AGENDA – Planning Commission Meeting

CITY OF SARATOGA SPRINGS

Site Plan

Harvest Point Commercial Plat A Lot 2

Exhibit 4: Site Plan

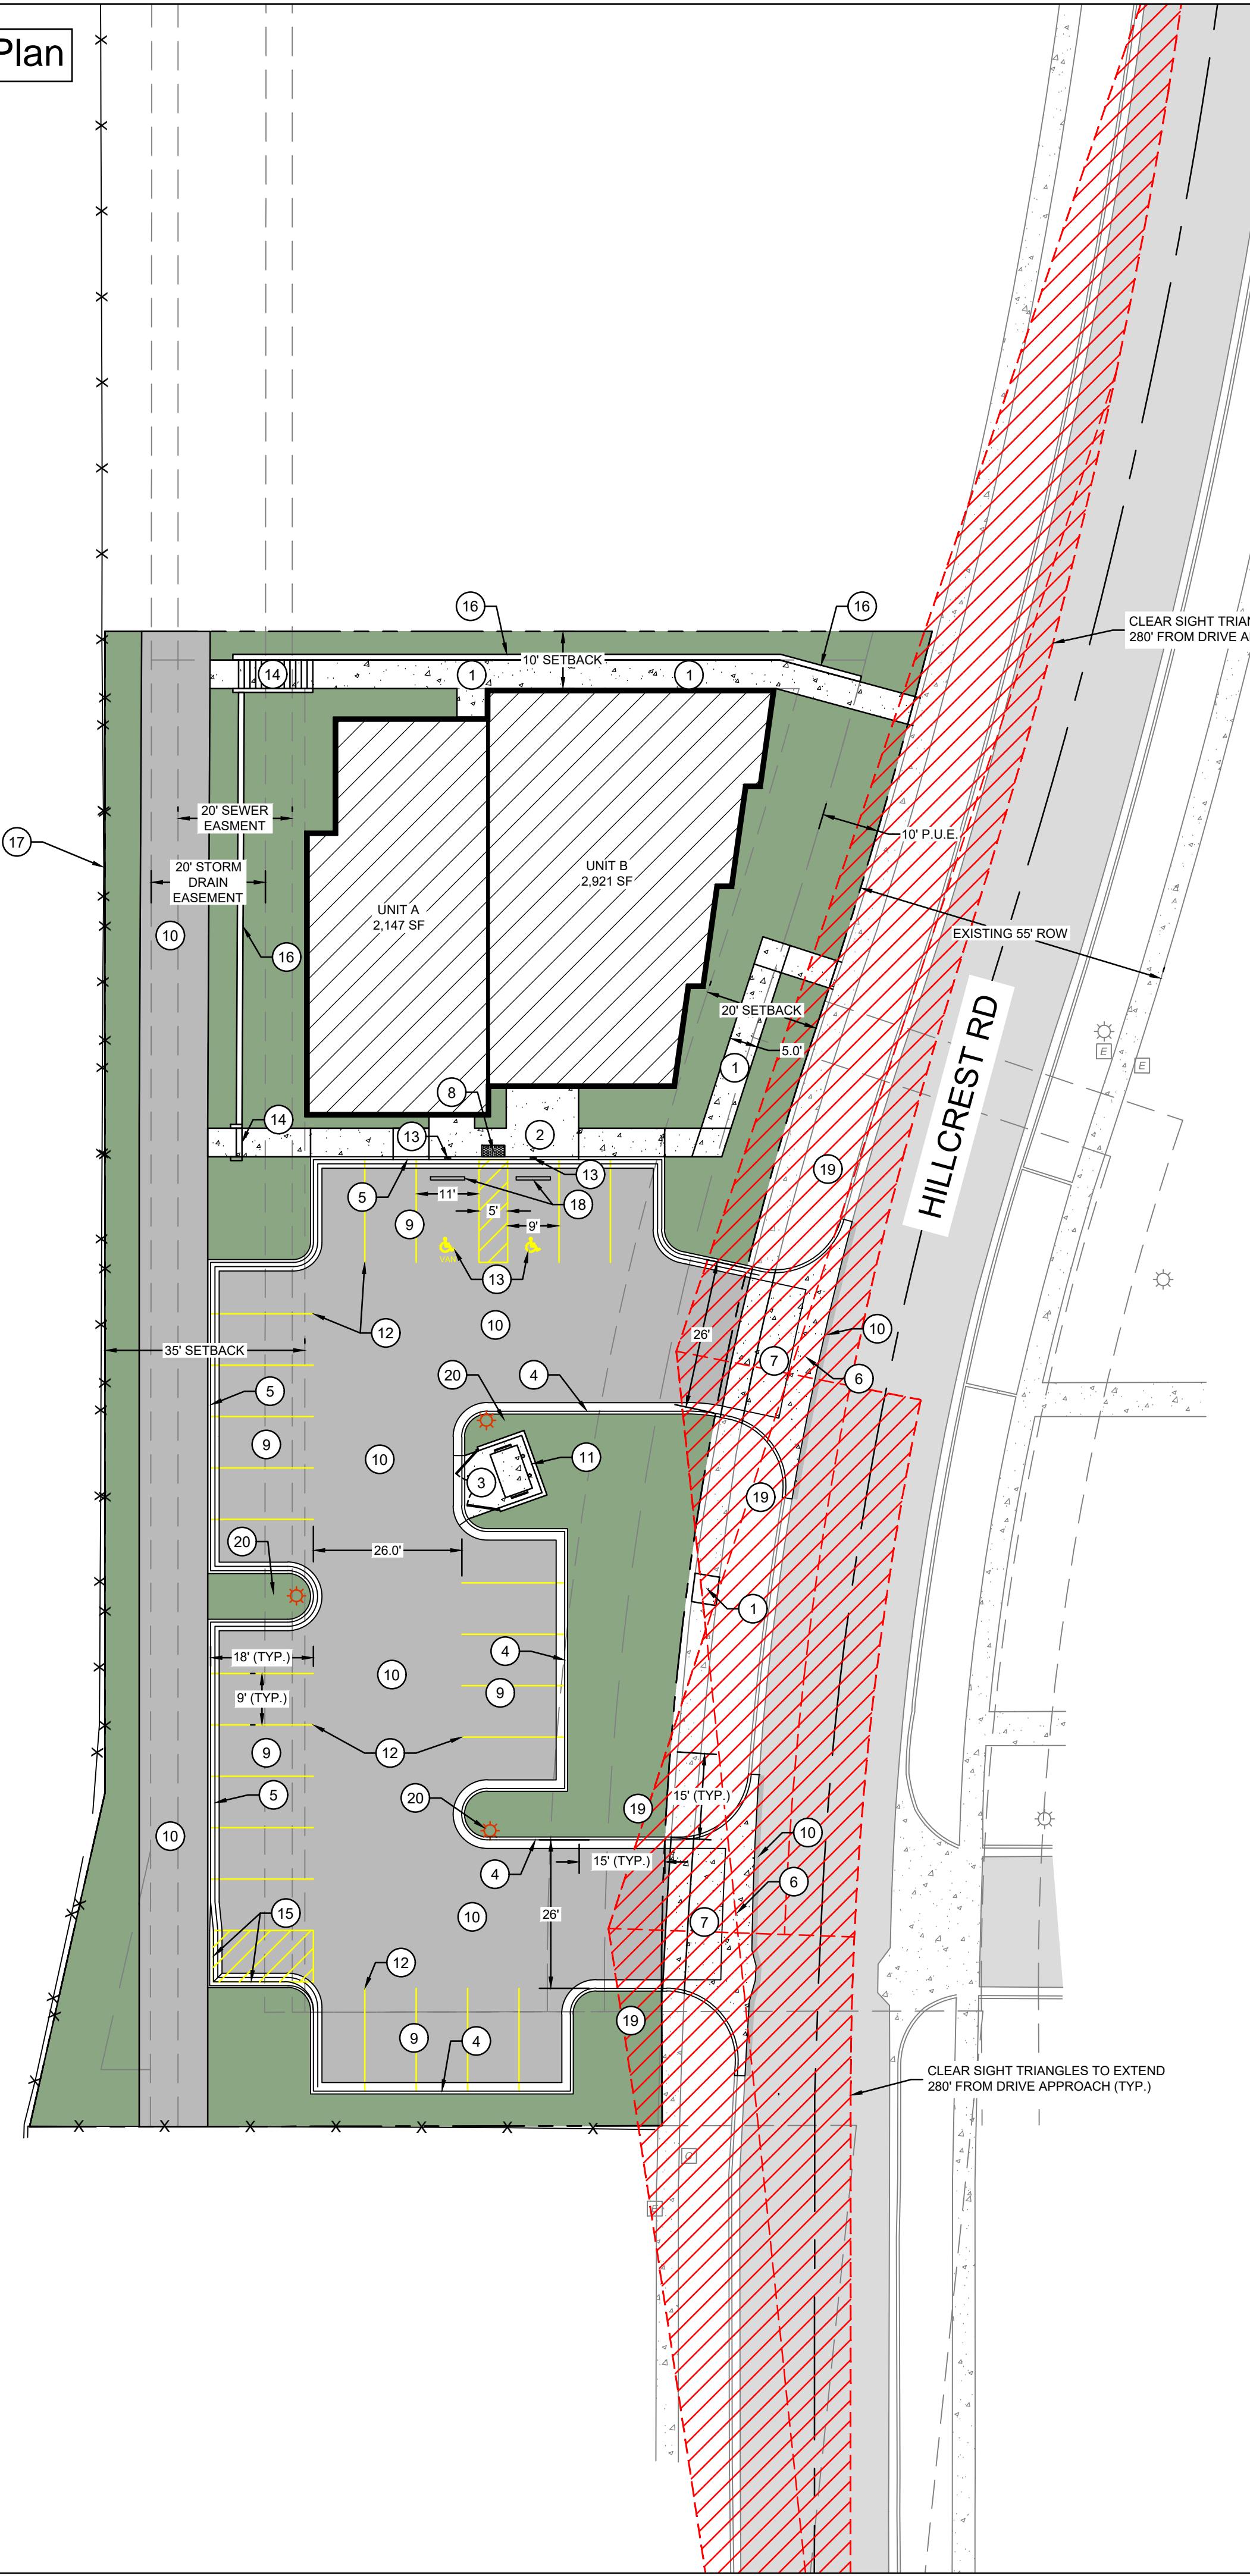
Final Hydraulic and Hydrological storm drainage report and calculations. location of all existing and proposed secondary irrigation systems, both on site and on adjacent properties, including ditches, pipes, and culverts;	Shall Comply.	<i>Checked by Engineering</i>
Final Traffic report: Said report shall comply with the standards outlined in the City's adopted Transportation Master Plan and shall include, but not be limited to, the following:	Complies.	<i>Provided</i>
Data table including: i. total project area ii. total number of lots, dwellings, and buildings iii. square footage of proposed building footprints and, if multiple stories, square footage by floor iv. number of proposed garage parking spaces v. number of proposed surface parking spaces	Complies.	<i>See data table on sheet C103</i>

L101

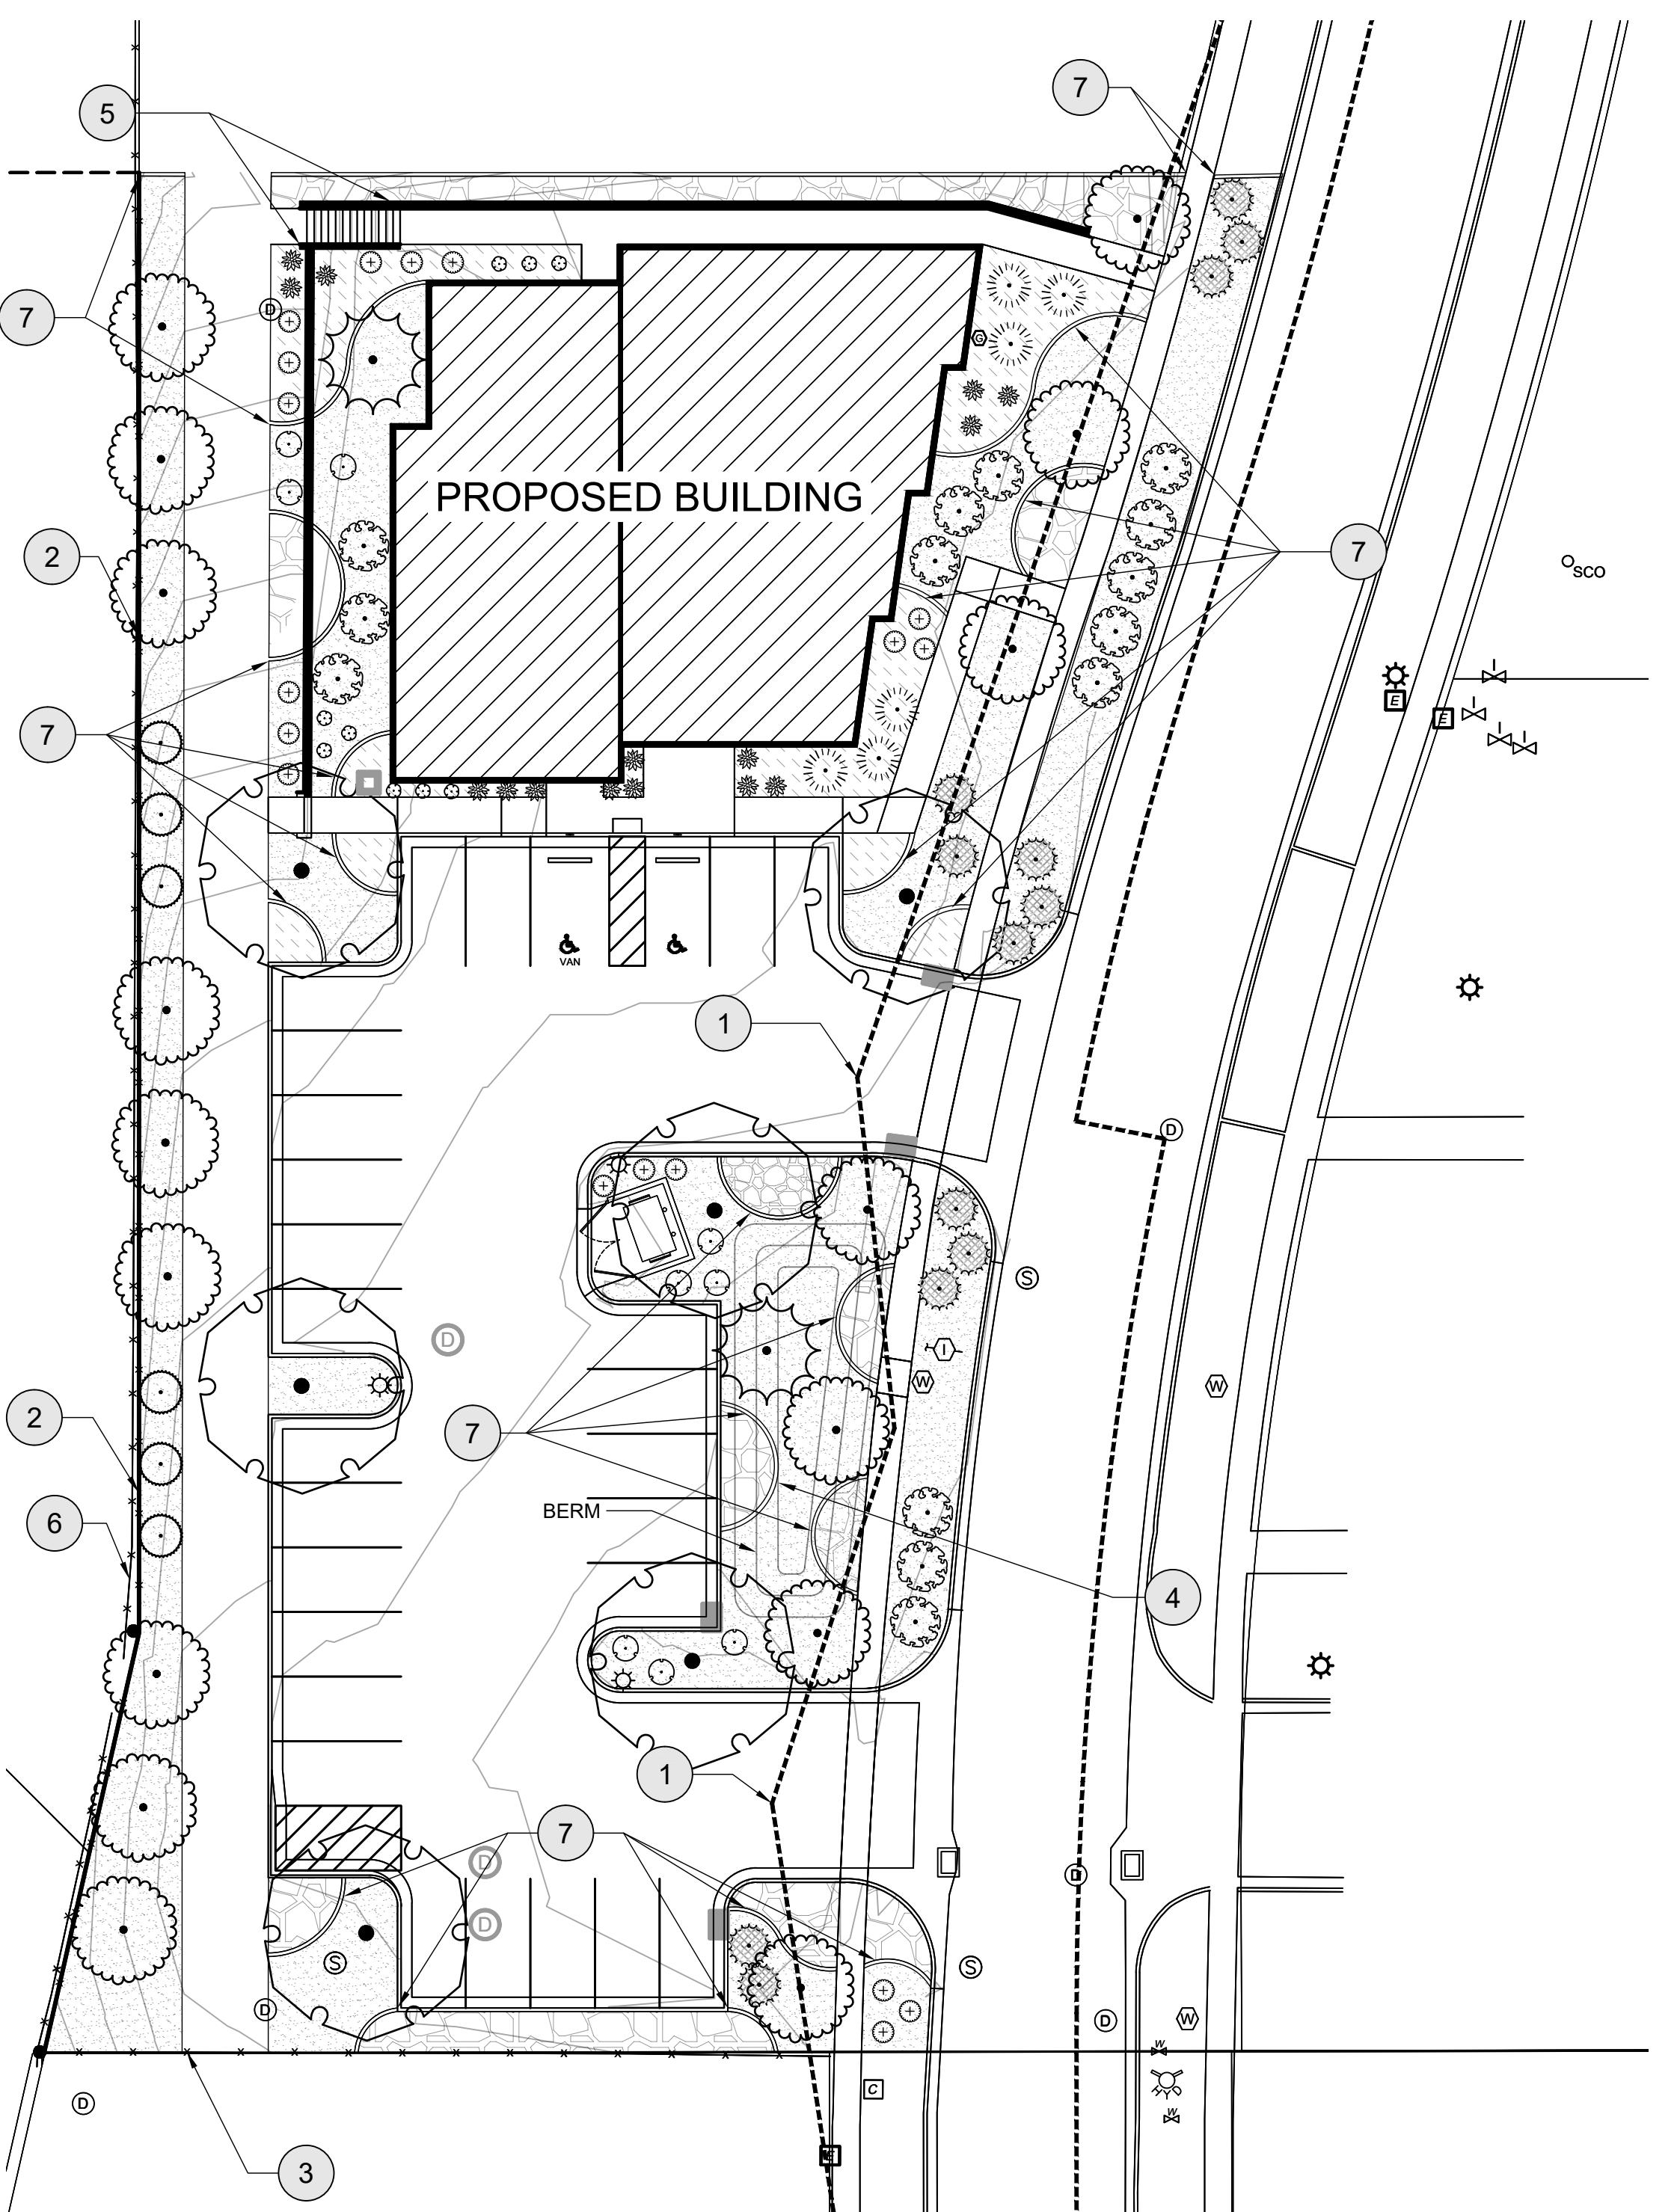
Deciduous Trees: Minimum 2" in caliper.	Complies.	<i>See sheet L101</i>
Evergreen Trees: Minimum 6' in height.	Complies.	<i>See sheet L101</i>

Energy Conservation: Placement of plants shall be designed to reduce energy consumption. Deciduous trees are encouraged to be planted on the south and west sides of structures. Evergreens are encouraged to be planted on the north side of structures.	Complies.	<i>See sheet L101</i>

Placement: Whenever possible, landscaping shall be placed immediately adjacent to structures, particularly where proposed structures have large empty walls.	Complies.	<i>See sheet L101</i>
Trees and Power Poles: No trees shall be planted directly under or within 10' of power lines, poles, or utility structures unless: <ol style="list-style-type: none"> The Land Use Authority gives its approval. The Power Company or owner of the power line gives written consent. The maximum height or width at maturity of the tree species planted is less than 5' to any pole, line, or structure. 	N/A.	<i>No overhead powerlines</i>

Portions of the property that are not developed with structures, rights of ways, or parking areas shall be required to be landscaped per the definition of Landscaping in Section 19.02 in all land use zones.	Complies.	<i>All areas not developed on are landscaped</i>
At least 50% of the landscaped area shall be covered with live vegetation at maturity, including shrubs, grasses, flowers, tree and shrub canopies and other live vegetation. The percentage may be reduced to 40% in areas where bark mulch, wood or plant fiber mulch, or rubber mulch is used instead of rock mulch.	Complies.	<i>66% provided. See Landscape Material Calculations table on sheet L101</i>
